MEETING AGENDA

7.	Sanitary: Amendment No. 1 to the Agreement for Technical Services for the Poplar Creek Lining Project.	X
8.	Plan Commission: Recommendation for Final Approval for a new warehouse building for Master Spa Warehouse located at 21675 Doral Rd.	X

**TOWN OF BROOKFIELD
PLANNING COMMISSION RECOMMENDATIONS
MAY 28, 2024**

Strand Associates, Inc.® (Strand) has finished its review of the plan package for the Avery and Birch Development that was received from ACS, Inc. on May 7, 2024, for conformance with the Town specifications and general engineering practices. Before construction may begin, the contractor shall submit all required permits for the development to the state, Wisconsin Department of Natural Resources, Town, and any other relevant agencies. New drawings and a letter describing the revisions should be returned to Strand after the following concerns have been addressed.

GRADING PLAN

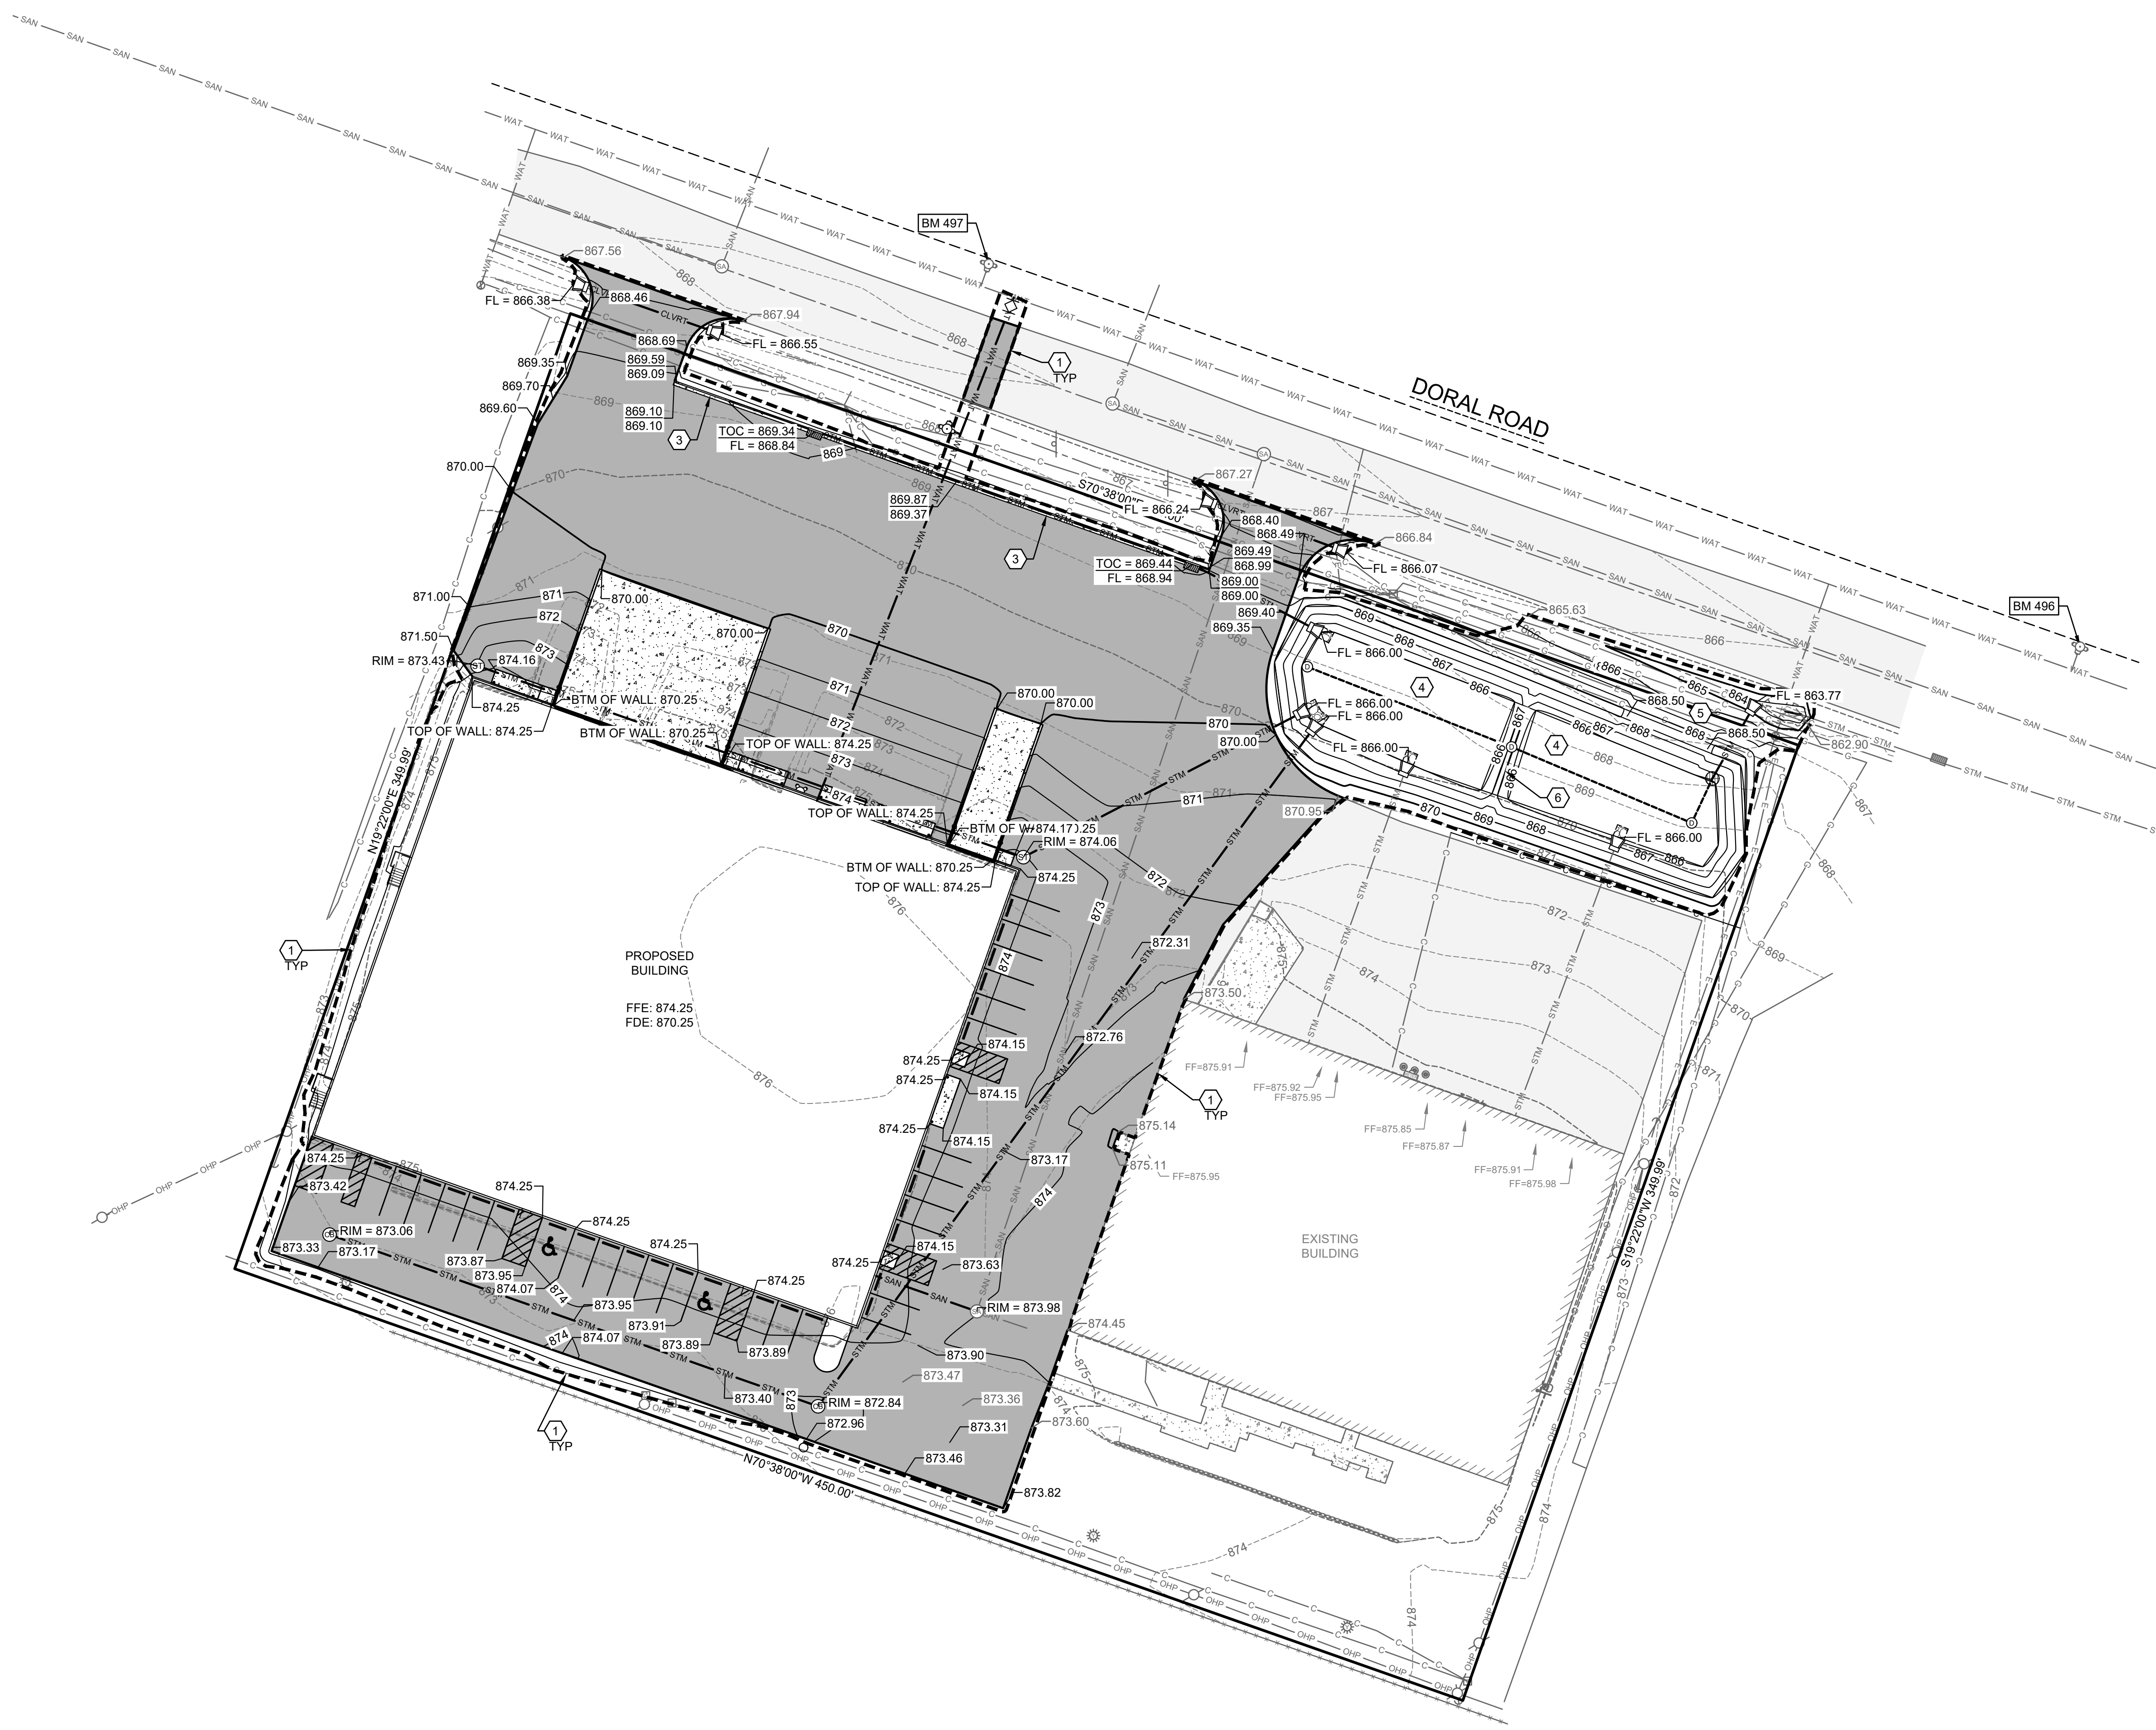
Grading Plan–Sheet C4.0

1. It appears that the width of the berm for the biofilter (elevation equal to 869.00) is only 1 foot wide. It is recommended to make this wider for ease of construction and maintenance.
 - a. **Mach IV Response–Top of berm width has been increased to 3 feet.**
 - b. *Strand’s Current Comment–Strand has no further comment.*
2. It is recommended to denote the top and bottom of wall elevations for the loading dock retaining walls or provide a construction detail for each wall.
 - a. **Mach IV Response–Top of berm width has been increased to 3 feet.**
 - b. *Strand’s Current Comment–It appears that the proposed berm width was increased to 3 feet. Strand has no further comment.*

LANDSCAPE PLAN

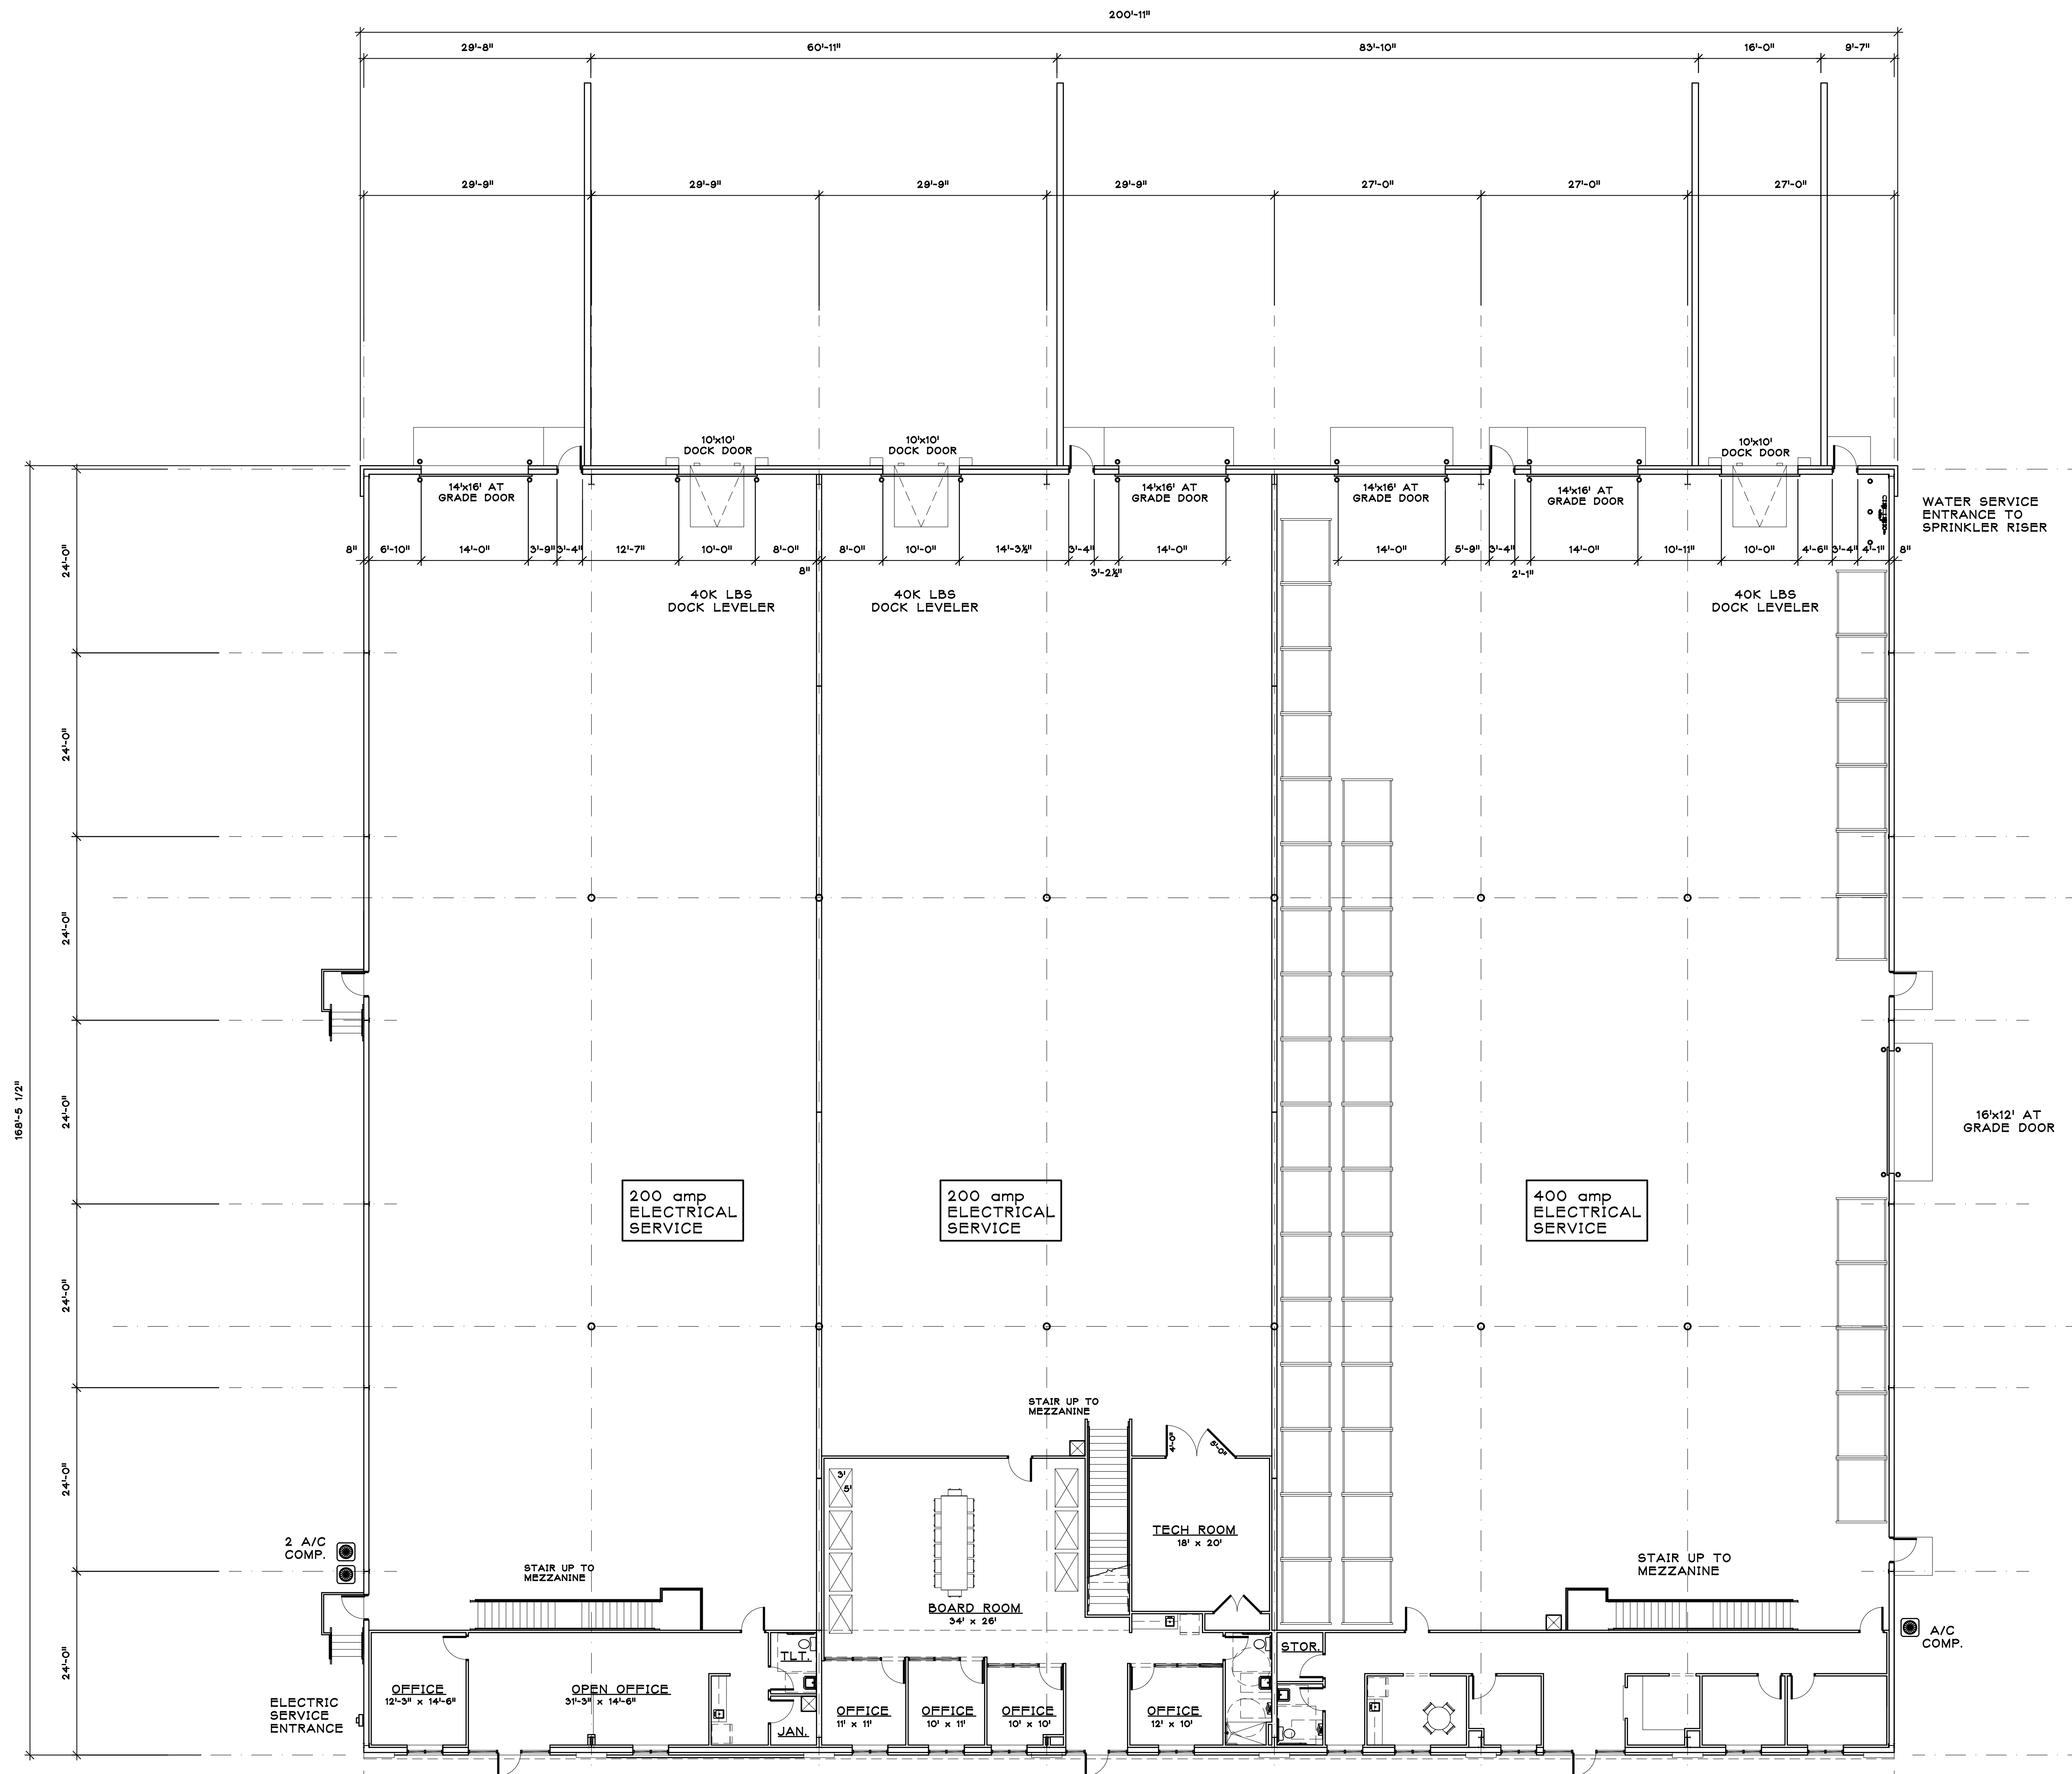
Landscape Plan

1. The landscape plan was reviewed and appears to be adequate for the site.
 - a. **Mach IV Response–Comment acknowledged.**
